Access Compliance Report

Public Rights-of-Way

(Curb Ramps)

Intersection ID: 47971	Main Street: SOUTH_CREEK_RD	Cross Street: KYRENE_RD	Location: W
ADA ID: B9D038E56923	Ramp Type: PerpDiag	Initial Pass/Fail: Fail	Overall Compliance: No
Severity Score: 21.25			
Codes/Mitigation Info/Possible Solution		Field Measurements/Component Compliance

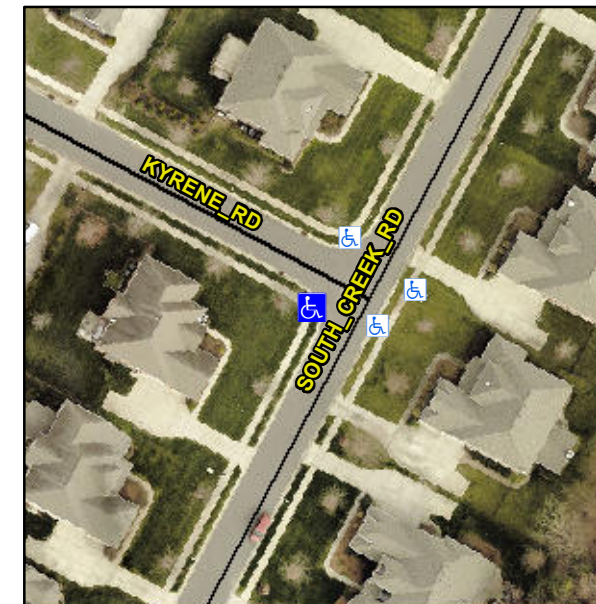
Not Found, R304.5.1, R304.5.3

Compliance	Description	Data	Compliance	Description	Data
N/A	Ramp Length (in)	47.0	Yes	Ramp Slope (%)	7.0
No	Ramp Width (in)	47.0	No	Ramp XSlope (%)	5.1
N/A	Flare Type LT	N/A	N/A	Flare Type RT	N/A
N/A	Flare Slope LT (%)	N/A	N/A	Flare Slope RT (%)	N/A
N/A	Flare Traversable LT?	N/A	N/A	Flare Traversable RT?	N/A
N/A	Landing Length (in)	N/A	N/A	DWS Provided?	N/A
N/A	Landing Width (in)	N/A	N/A	DWS Contrast?	N/A
N/A	Landing Slope (%)	N/A	N/A	DWS Length (in)	N/A
N/A	Landing X Slope (%)	N/A	N/A	DWS Full Width?	N/A
N/A	Landing Curb? (Y/N)	N/A	N/A	DWS Offset (in)	N/A
N/A	Shared Landing?	N/A			
N/A	Gutter Ponding?	N/A	N/A	Gutter Slope (%)	N/A
N/A	Gutter Lip Ht (in)	N/A	N/A	Gutter X Slope (%)	N/A
N/A	Painted X Walk1?	No	N/A	Painted X Walk2?	No
	X Walk 1 Direction	To SE		X Walk 2 Direction	To NE
N/A	X Walk 1 Width (in)	N/A	N/A	X Walk 2 Width (in)	N/A
	X Walk 1 Slope (%)	3.7		X Walk 2 Slope (%)	0.7
	X Walk 1 X Slope (%)	2.4		X Walk 2 X Slope (%)	3.2

N/A	Ramp inside XWalk1?	N/A	N/A	Ramp inside XWalk2?	N/A
	Road Slope (%)	3.3	N/A	Clear Space?	N/A
	Road X Slope (%)	1.9	N/A	Clear Space to XWalk (in)	N/A
N/A	Any Obstructions?	N/A	N/A	Storm Grate/Utility Hazard?	N/A
	Obstruction Type			Storm Grate/Utility Type	
		N/A			N/A
			Yes	Surface Condition? (G/P)	Good

Remove & Replace Curb Ramp With Two New Directional Ramps or Equivalent.
